Prepared by:
The Dredged Material Management Office
Seattle District, U.S. Army Corps of Engineers

MEMORANDUM FOR RECORD

SUBJECT: SUPPLEMENTAL DETERMINATION REGARDING THE SUITABILITY/UNSUITABILITY OF PROPOSED DREDGED MATERIAL FROM BELLINGHAM COLD STORAGE, EVALUATED UNDER SECTION 404 OF THE CLEAN WATER ACT, FOR UNCONFINED OPEN-WATER DISPOSAL AT THE PORT GARDNER NONDISPERSIVE SITE.

Figure 2

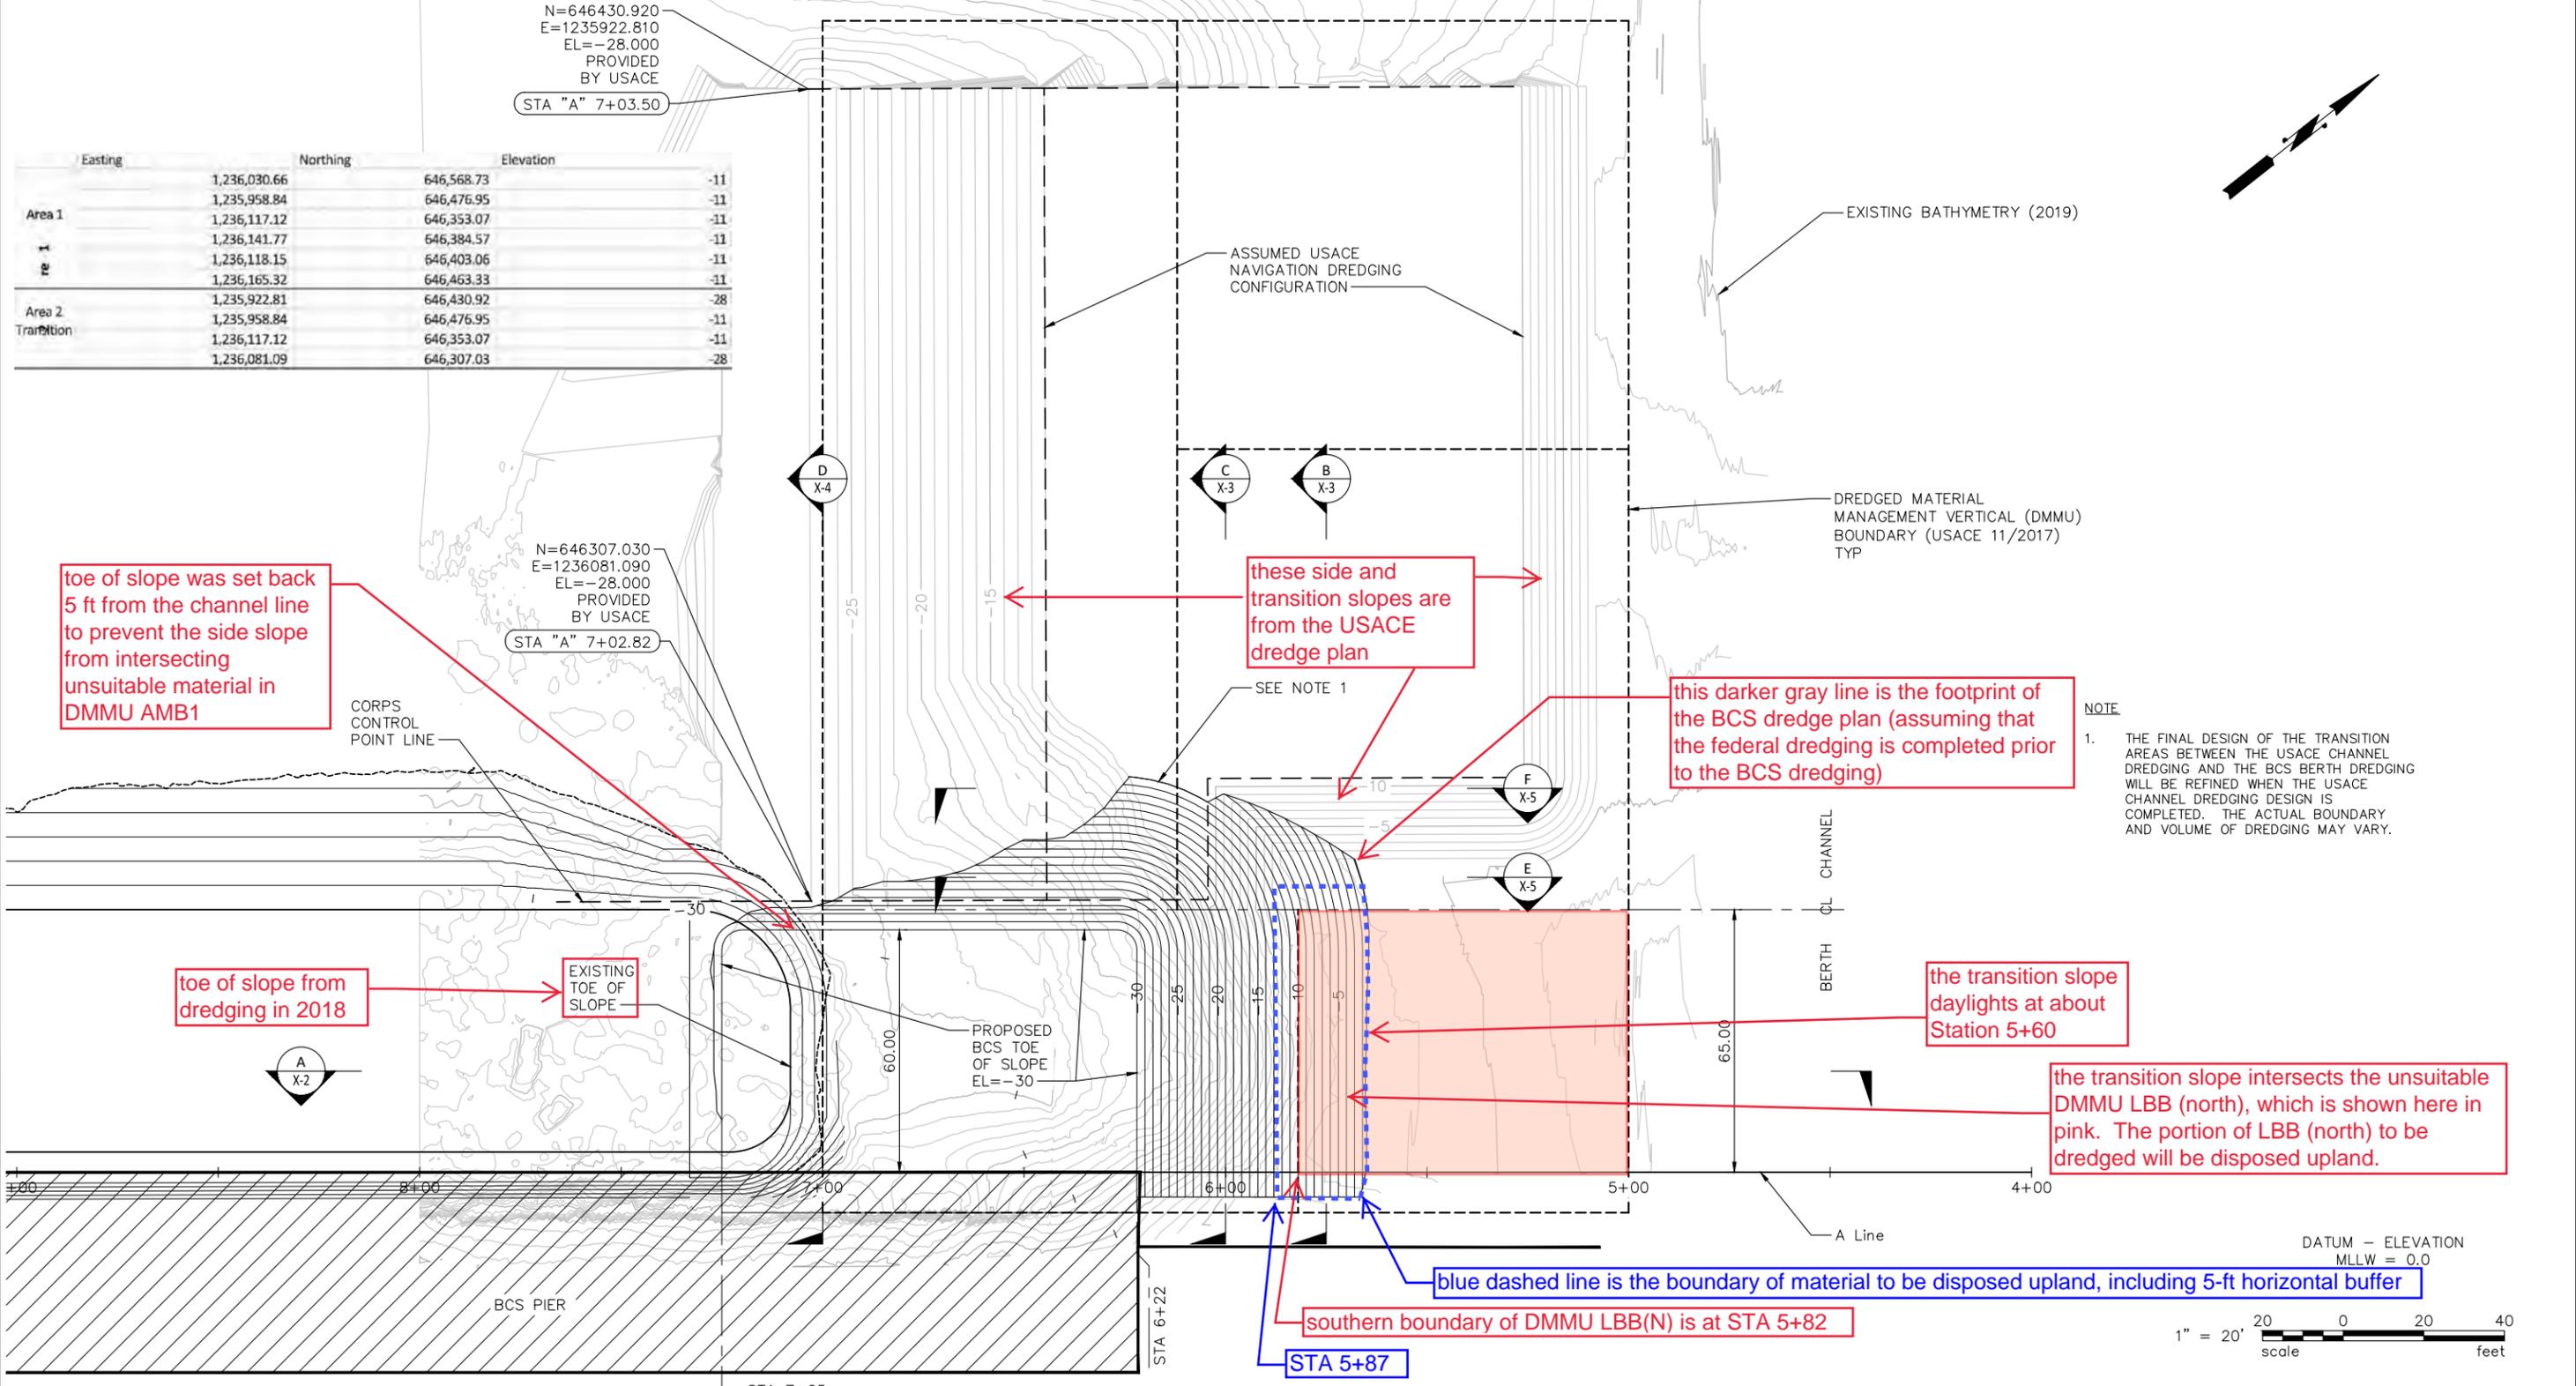
The exception is shown in Section D (Figure 5). The toe of slope along the northwest side of the berthing area (parallel to the channel) was set back 5 ft from the channel line (see Figure 2) to prevent the side slope from intersecting unsuitable material in DMMU AMB1. If all of the overdepth and advanced maintenance material is dredged, only 6 inches of suitable material will remain in place along the outer edge of AMB1. Further narrowing of the berthing area to increase the vertical buffer is undesirable from an operational standpoint. Since a 1-ft cover over AMB1 will be present within a foot of the toe of slope (given a side-slope ratio of 2V:1H), the DMMP agencies agreed this minor deviation was inconsequential and could be approved.

Figure 3

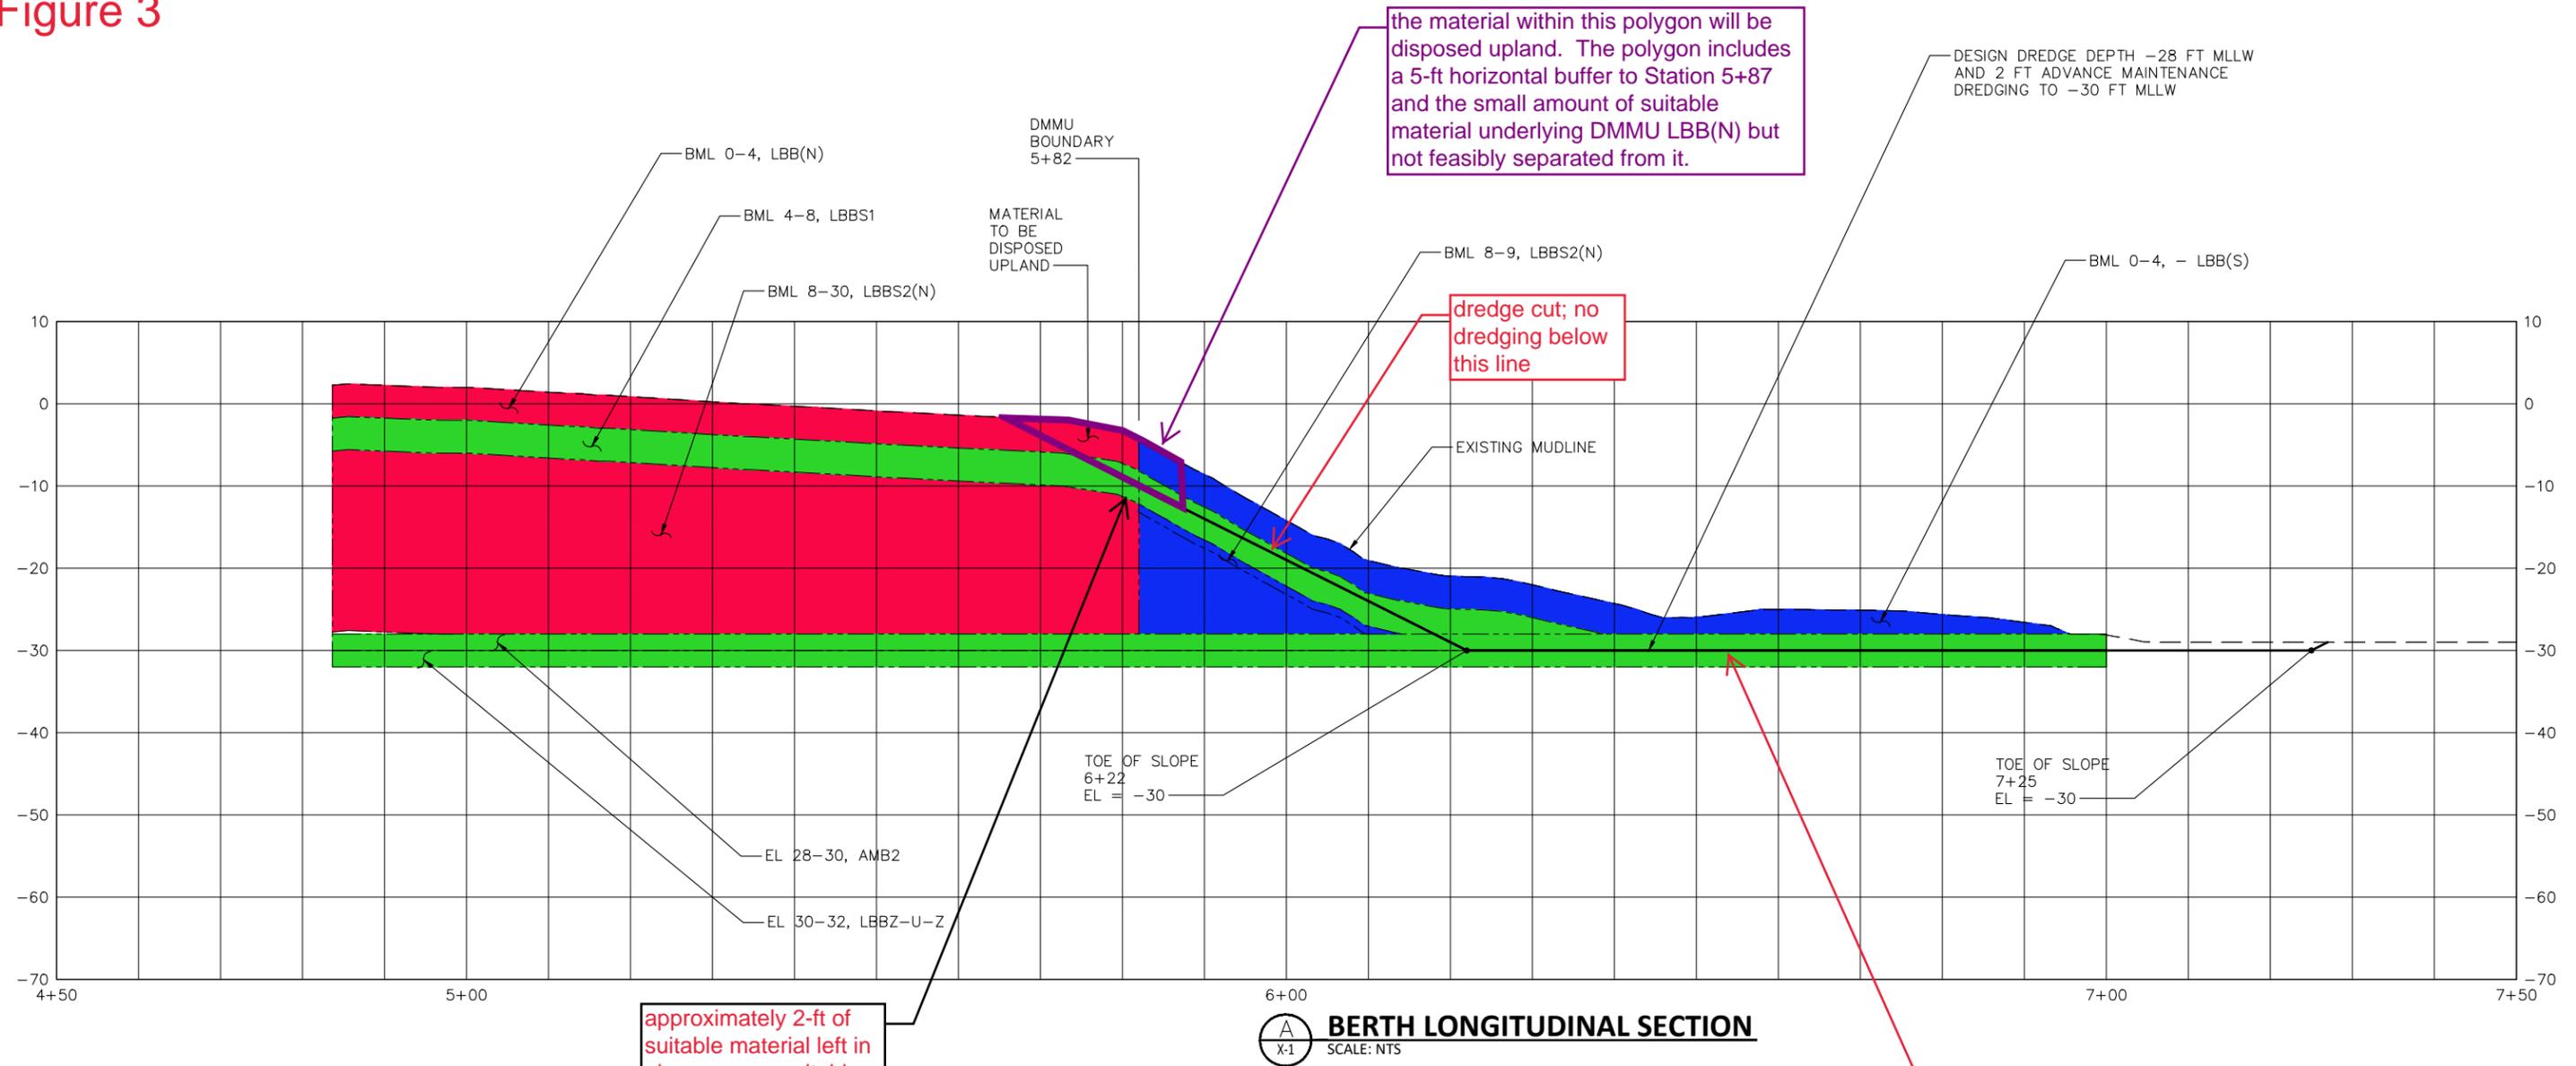
- c. With one minor exception, the dredge plan leaves a 1-ft vertical buffer between suitable and unsuitable material, as shown in the cross-sections in Figures 3 through 6. For example, as shown in Section A (Figure 3), the dredge cut leaves a minimum of 2 ft of suitable material overlying the unsuitable material in DMMU LBBS2(N).

Figure 6

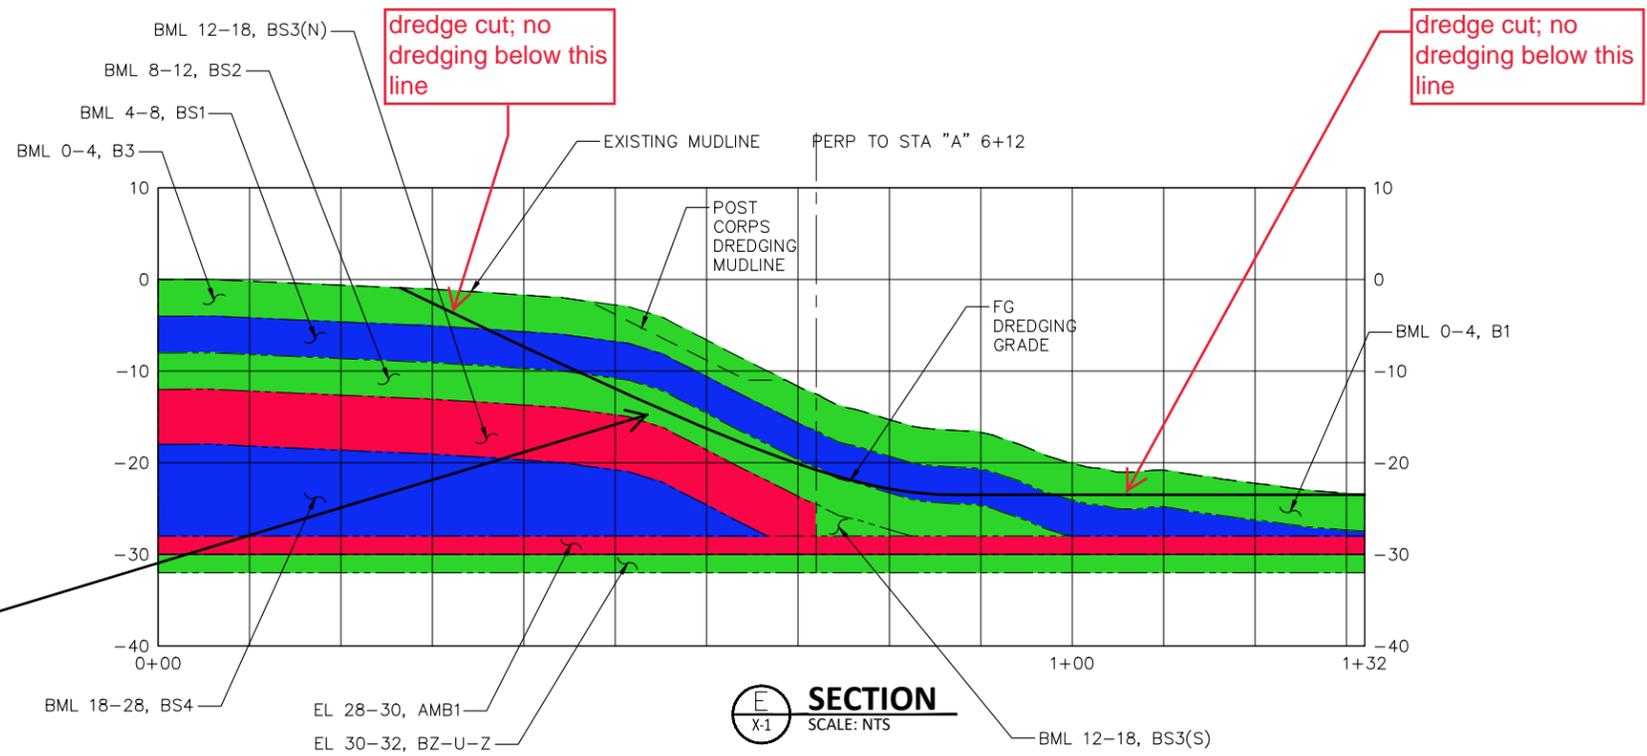
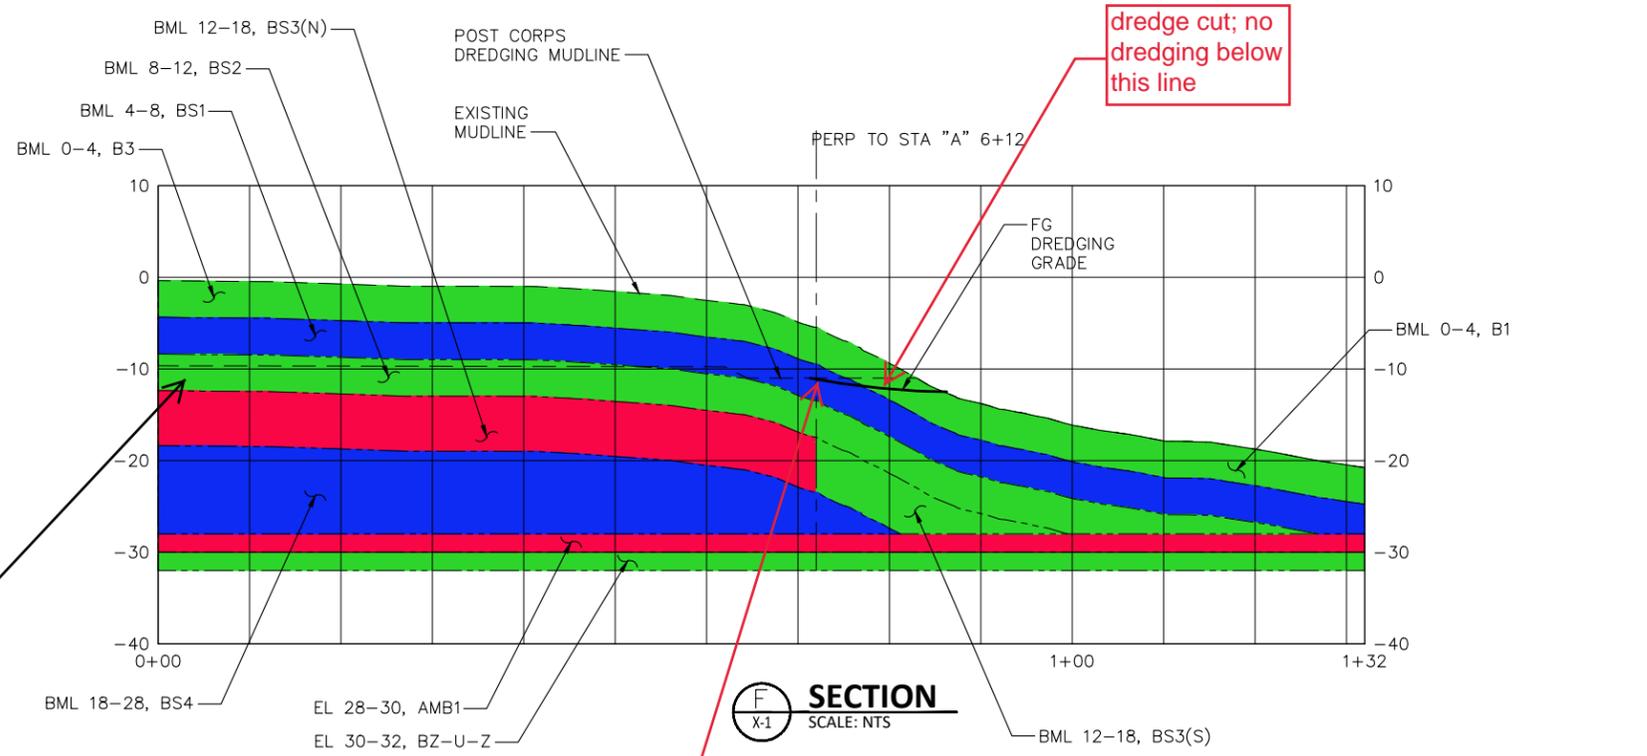
approximately 2-3 ft of suitable material left in place over unsuitable DMMU BS3(N)

approximately 2-3 ft of suitable material left in place over unsuitable DMMU BS3(N) following dredging by USACE

the BCS dredge prism intersects the USACE dredge prism at this point; there is no BCS dredging to the left (north) of this point of intersection
